PMC Servo Board
D980352-A 40m version
Nov 19, 2015 KA
(DCC entry D1400221)

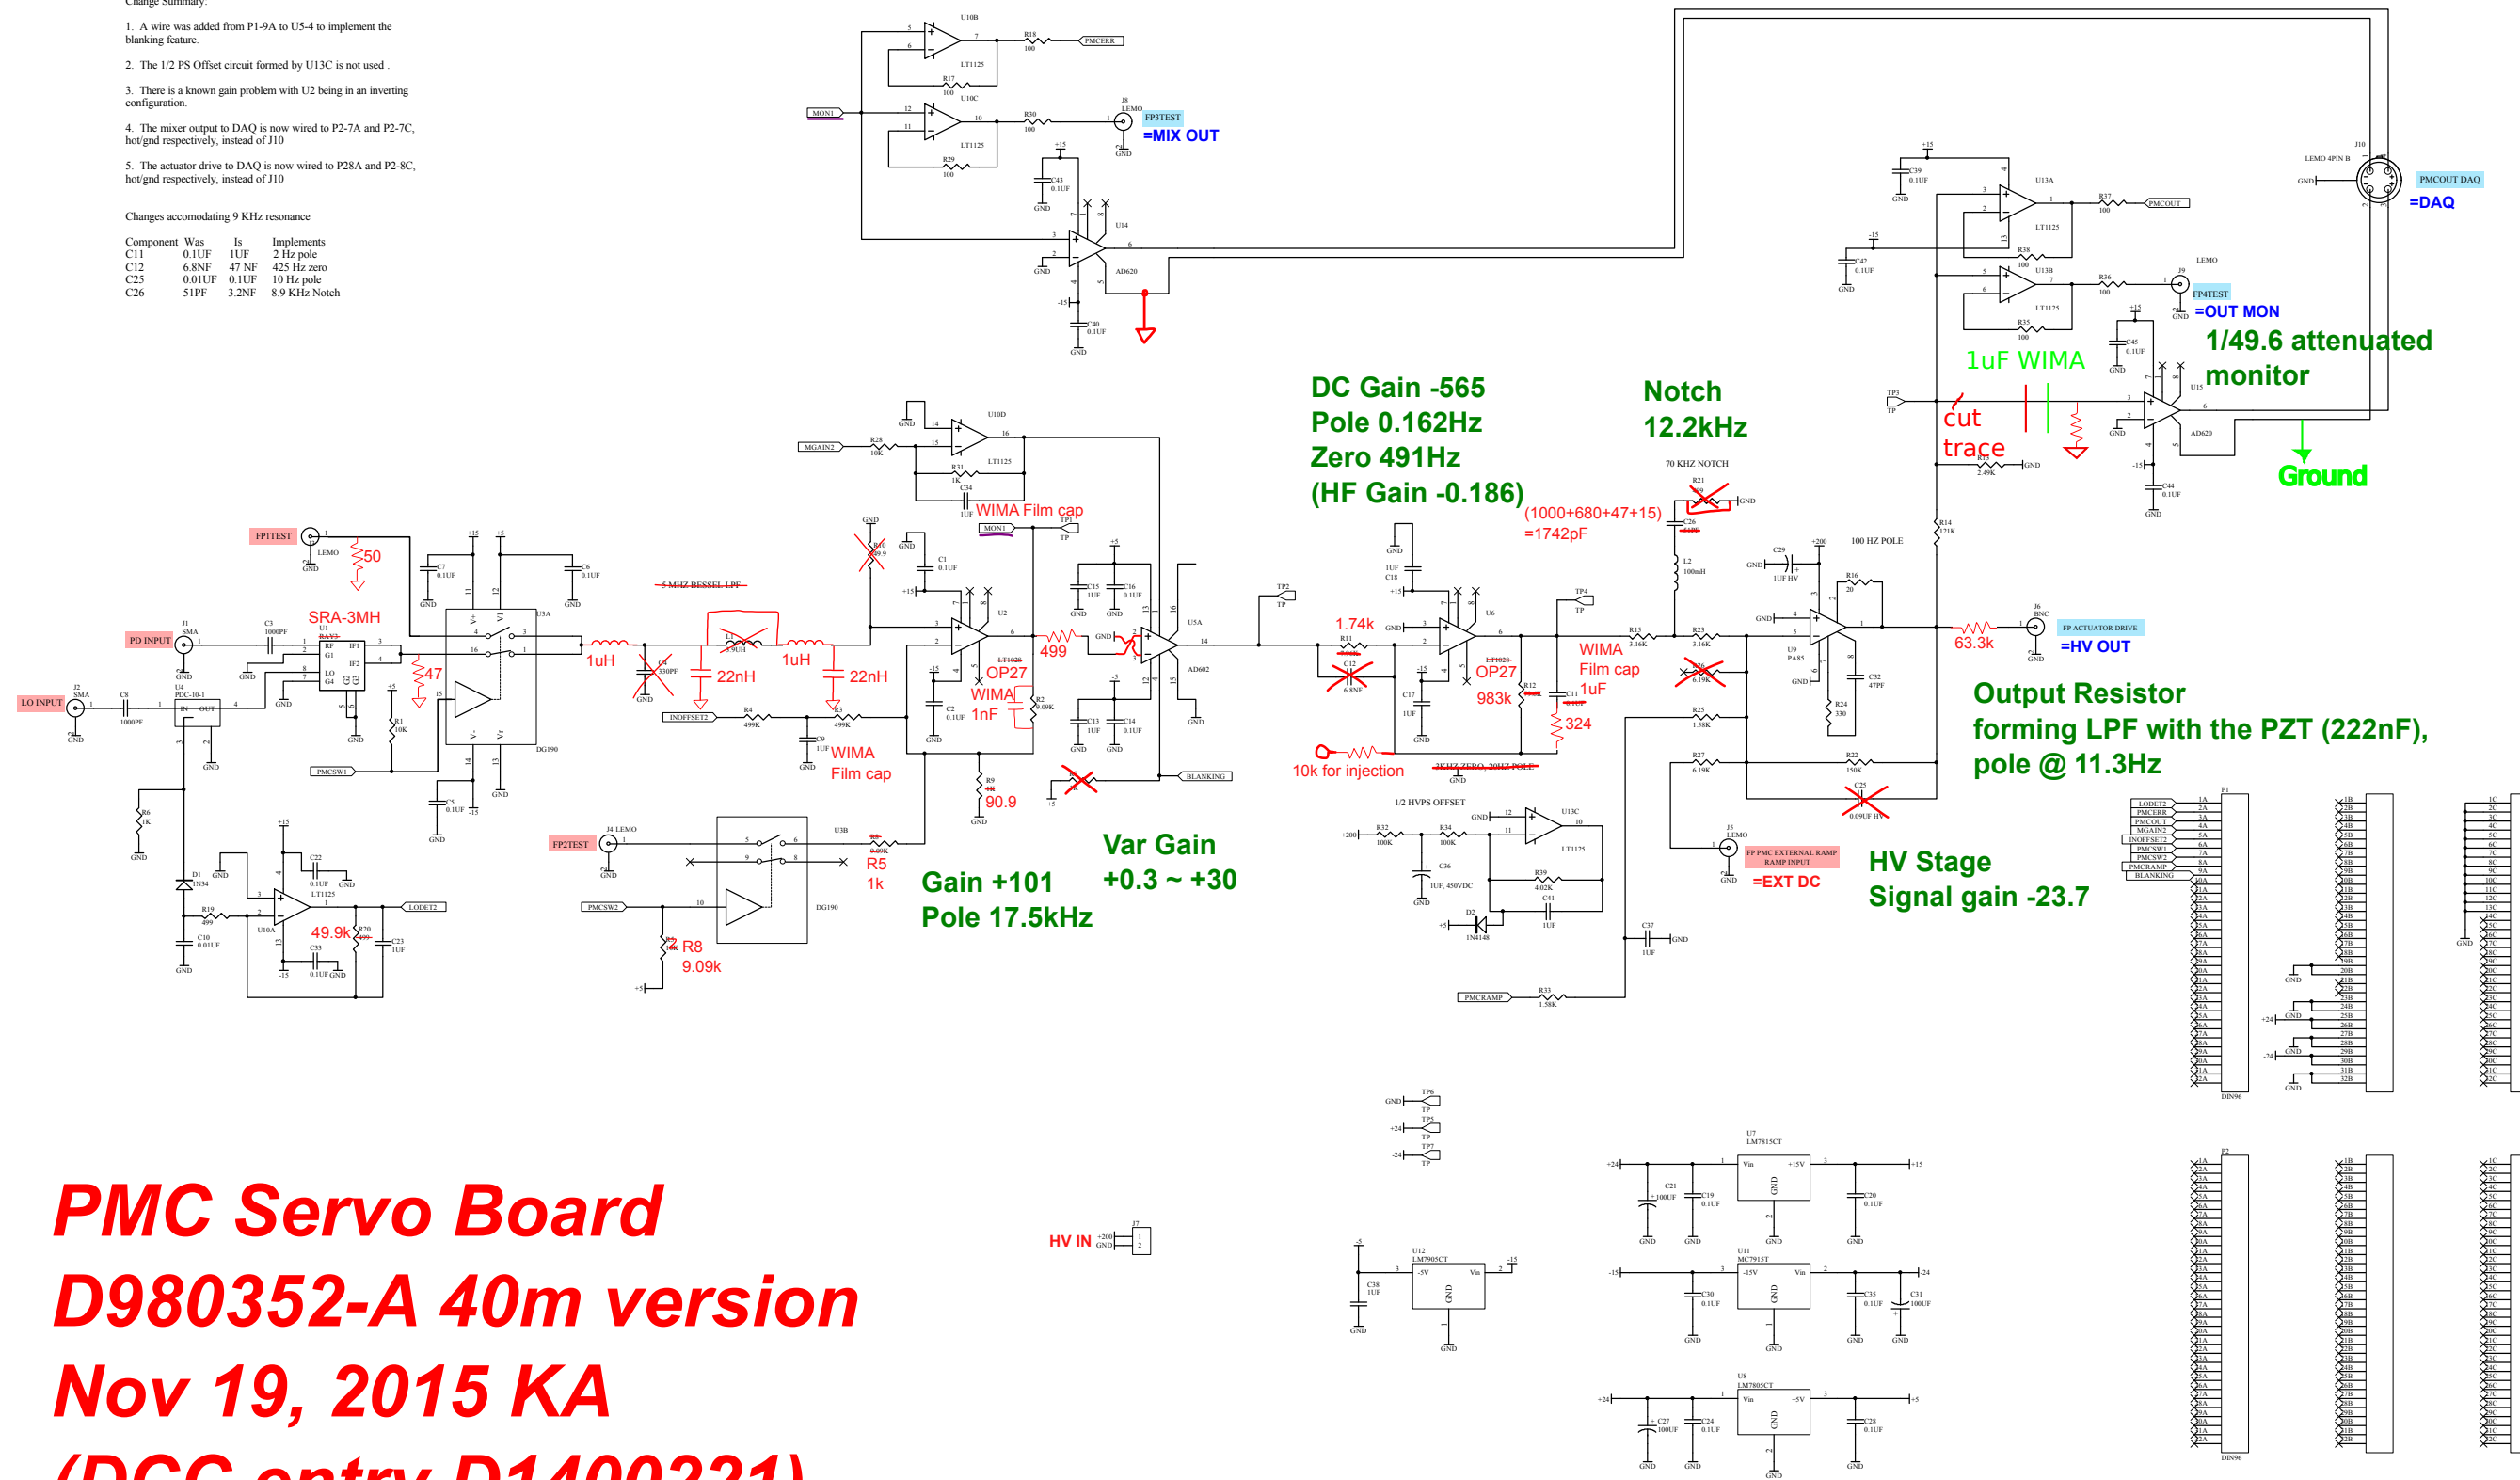
Change Summary:

1. A wire was added from P1-9A to U5-4 to implement the blanking feature.
2. The 1/2 PS Offset circuit formed by U13C is not used.
3. There is a known gain problem with U2 being in an inverting configuration.
4. The mixer output to DAQ is now wired to P2-7A and P2-7C, hot/gnd respectively, instead of J10
5. The actuator drive to DAQ is now wired to P28A and P2-8C, hot/gnd respectively, instead of J10

Changes accomodating 9 KHz resonance

Component	Was	Is	Implements
C11	0.1uF	1uF	2 Hz pole
C12	6.8nF	47 nF	425 Hz zero
C25	0.01uF	0.1uF	10 Hz pole
C26	51pF	3.2nF	8.9 KHz Notch
